UNITED STATES PATENT AND TRADEMARK OFFICE

APPLICATION NO.	FILING DATE	FIRST NAMED INVENTOR	ATTORNEY DOCKET NO.	CONFIRMATION NO.
10/627,623	07/28/2003	Reuven Unger	P23593	4331

Office Action Summary	Application No. 10/627,623	Applicant(s) UNGER ET AL.	
	Examiner Ernesto Garcia	Art Unit 3679

DETAILED ACTION

Sergeant, 2,110,427

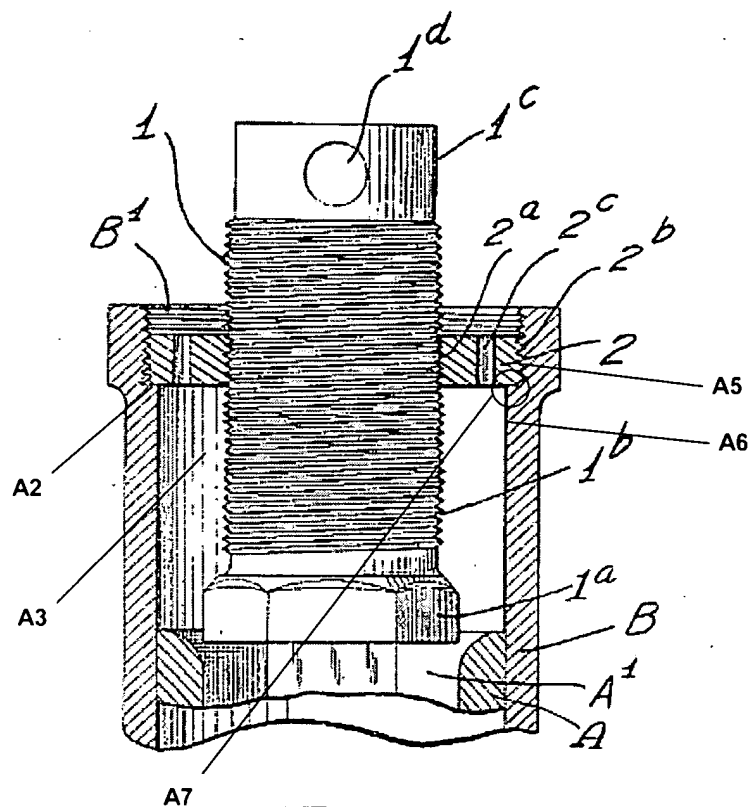
Claims 1-3, 5-7, and 9 are rejected under 35 U.S.C. 102(b) as being anticipated by Sergeant, 2,110,427 (see marked-up attachment).

Regarding claim 1, Sergeant discloses, in Figure 1, a securing device comprising a generally annular spring support **B** and a generally annular coupling ring **2**. The spring support **B** includes a spring mount **A2** projecting in an inner side **A3** of the spring support **B**.

Regarding claims 2 and 6, the spring support **B** has a first inner diameter **A5** and second inner diameter **A6**. The spring mount **A2** radially inwardly projects at a region **A7** between the first inner diameter **A5** and the second inner diameter **A6**.

Regarding claims 3 and 7, a first thread **B1** is formed on an inner periphery of the spring mount **A2**. A second thread **2b** is formed on an outer periphery of the coupling ring **2**.

Regarding claim 5, Sergeant discloses, in Figure 1, a securing device comprising a generally annular spring support **B**, a generally annular coupling ring **2**, and fixation holes **2c**. The spring support **B** includes a spring mount **A2** projecting in an inner side

A3 of the spring support **B**. The fixation holes **2c** are penetratingly formed through the coupling ring **2**.

Regarding claim 9, the fixation holes **2c** are at an interval of approximately 90 degrees or 180 degrees on the coupling ring **2**.

Dukert et al., 3,570,062

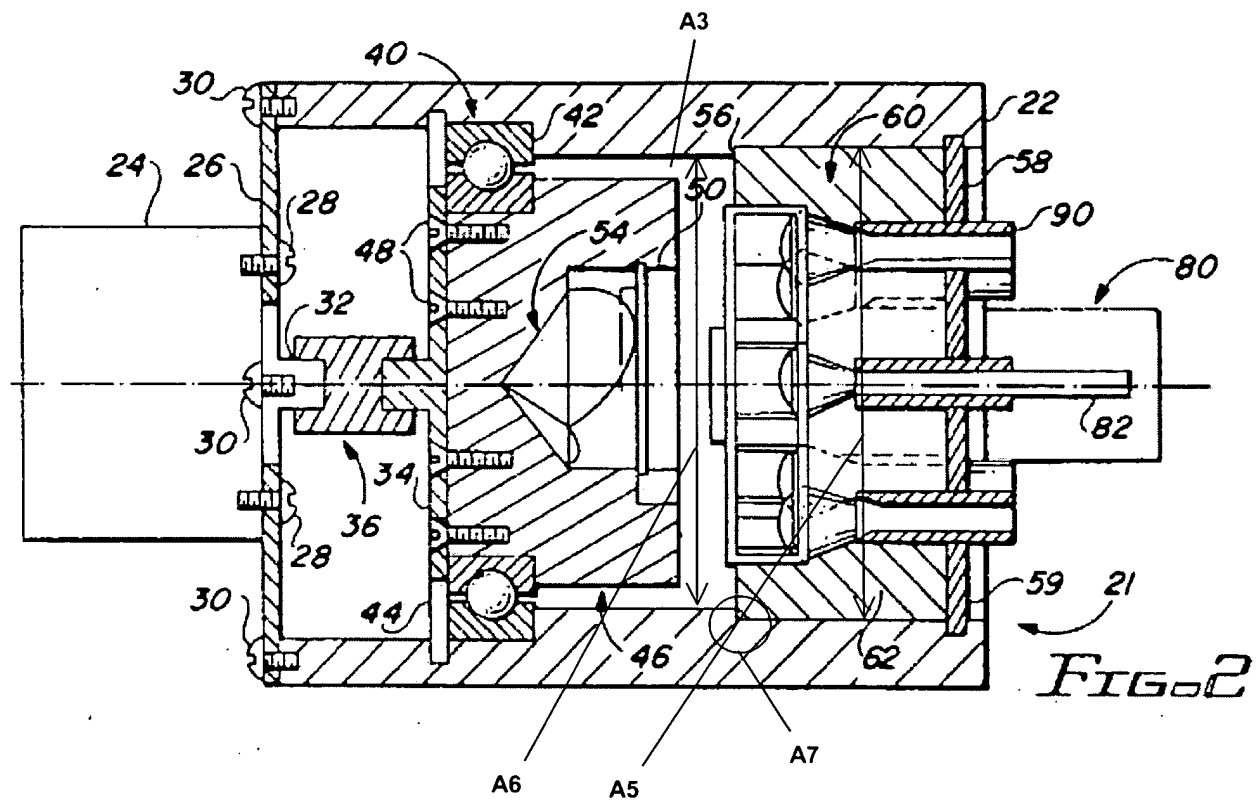
Claims 10 and 12 are rejected under 35 U.S.C. 102(b) as being anticipated by Dukert et al., 3,570,062 (see marked-up attachment).

Regarding claim 10, Folsom et al. disclose, in Figures 2 and 3, a securing device comprising a generally annular spring support **56**, a generally annular coupling ring **50**, and threaded holes **A11**. The spring support **56** includes a spring mount **A2** projecting in an inner side **A3** of the spring support **56**. The threaded holes **A11** are penetratingly formed through the coupling ring **50**.

Regarding claim 12, a first thread **A8** is formed on an inner periphery of the spring mount **A2**. A second thread **52** is formed on an outer periphery of the coupling ring **50**.
